Hudson County 69kV Projects Update

August 27, 2019

Scope Changes to s0239, s0483, and s1016

Reference: s0239

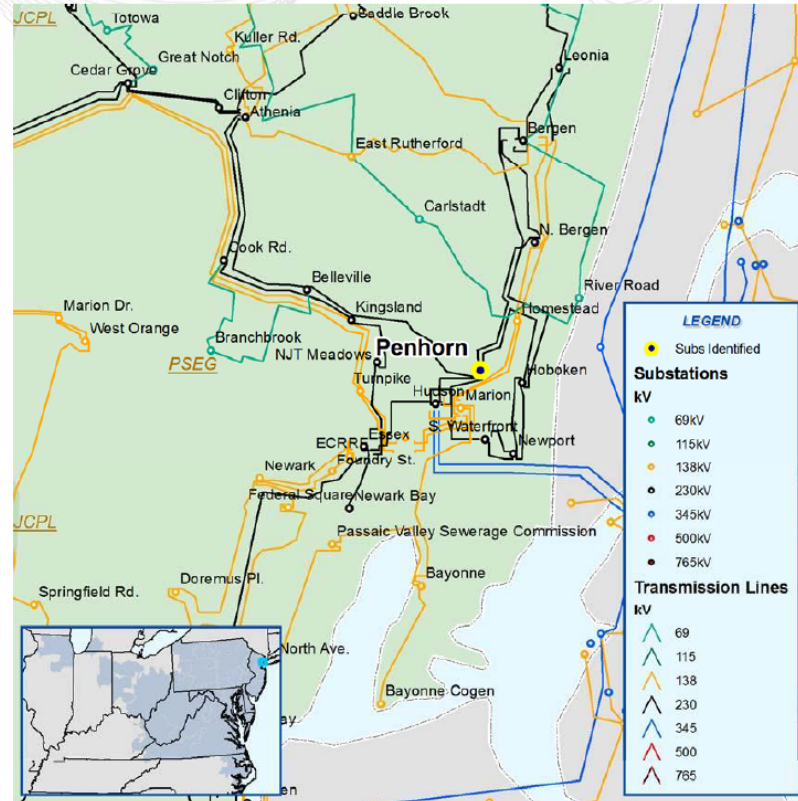
s0239: Penhorn to Madison only requires a single circuit due to interconnection with other area projects.

Reference: s0483

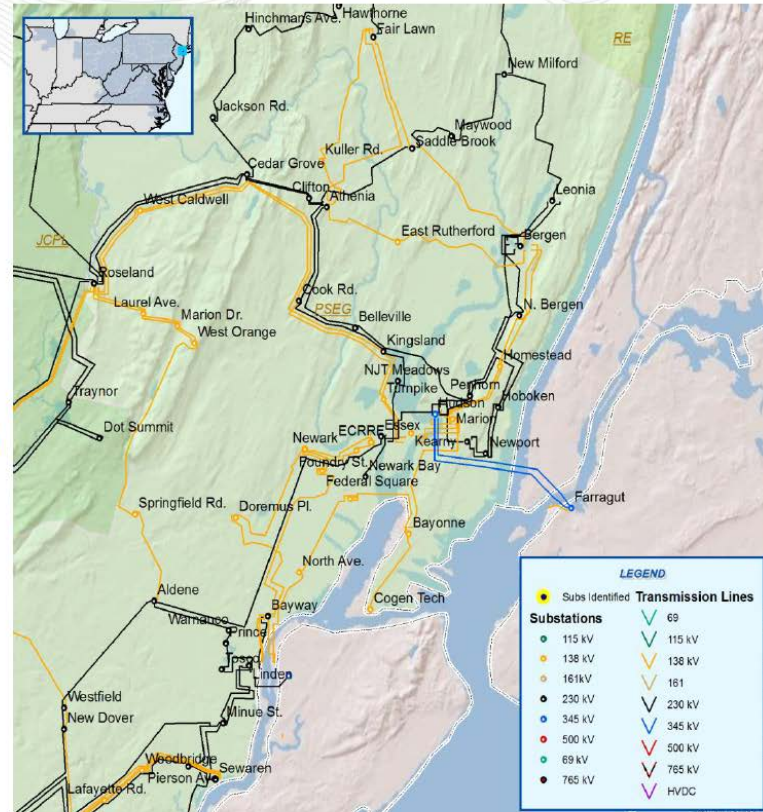
s0483: Project terminates at Penhorn 69kV rather than Newport.

Reference: s1016

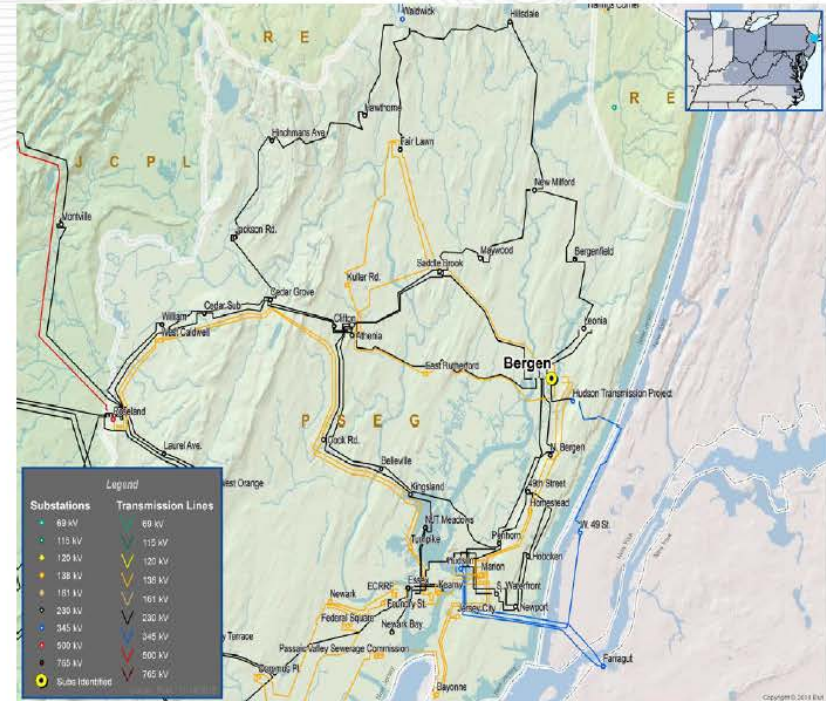
s1016: De-scope 230kV ring at Madison. Madison 230/69kV transformer is moved to Penhorn.
